# Manual Supplement

Manual Title:	744 Users	Supplement Issue:	4
Part Number:	691287	Issue Date:	9/03
Print Date:	September 1998	Page Count:	7
Revision/Date:	1, 2/99

This supplement contains information necessary to ensure the accuracy of the above manual.

Figure A. Sourcing Temperature using Drywell

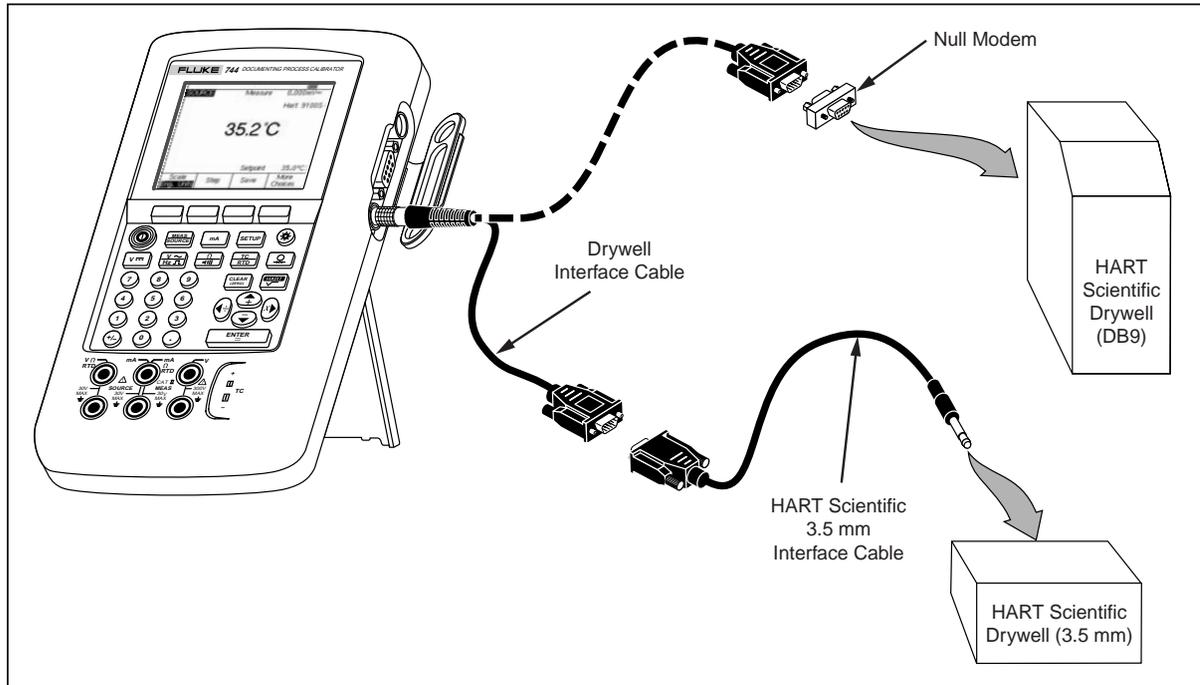
On page 59, before **Source Scale**, add the following:

Connect the 744 to the drywell by plugging the drywell interface cable into the pressure module connector as shown in Figure A. If the drywell has a DB9 connector, plug the drywell interface cable directly into the drywell using the DB9 Null Modem adapter. Drywells with the 3.5 mm jack connector need to use the serial cable supplied with the drywell in addition to the 744 drywell interface cable. Join the DB9 connectors of the two cables, and connect the 3.5 mm jack to the drywell.

Be sure the drywell is configured for serial communication at 2400, 4800, or 9600 bits per second. Other rates are not supported by the 744.
